INDEPENDENT ENVIRONMENTAL AUDIT

TASMAN UNDERGROUND COAL MINE

SEAHAMPTON NSW

19 JANUARY 2009

Figure 3: Surface Layout and Drainage Development - Tasman Mine Stormwater Management Plan

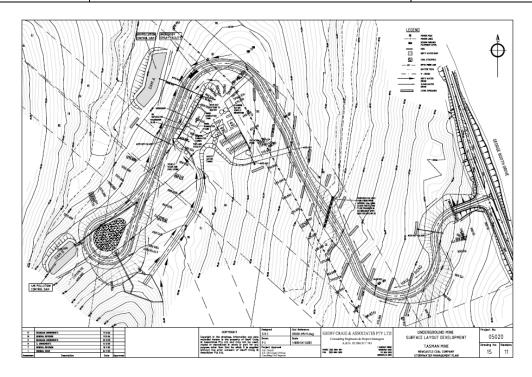
| Environme | Environmental Protection Licence No. 12483 | | | | | | |
|---------------|--|---|------|--------|--|--|--|
| O4.1 | A Stormwater Management Scheme must be prepared for the development and must be implemented. Implementation of the Scheme must mitigate the impacts of stormwater runoff from and within the premises following the completion of construction activities. The Scheme should be consistent with the Stormwater Management Plan for the catchment. If a Stormwater Management Plan has not yet been prepared the Scheme should be consistent with the guidance contained in the publication "Managing Urban Stormwater: Soils and Construction" (Landcom, 2004), or as revised. | Site Water Management Plan 12 April 2006 Surface Layout Development, Drawing 15, Geoff Craig & Associates 2006 | | | A Stormwater Management Plan has been developed for the site and the drains and erosion control structures established to management surface runoff from the site works areas (refer to Surface Layout and Drainage Development – Tasman Mine Stormwater Management Plan section 4 of this report). | | |
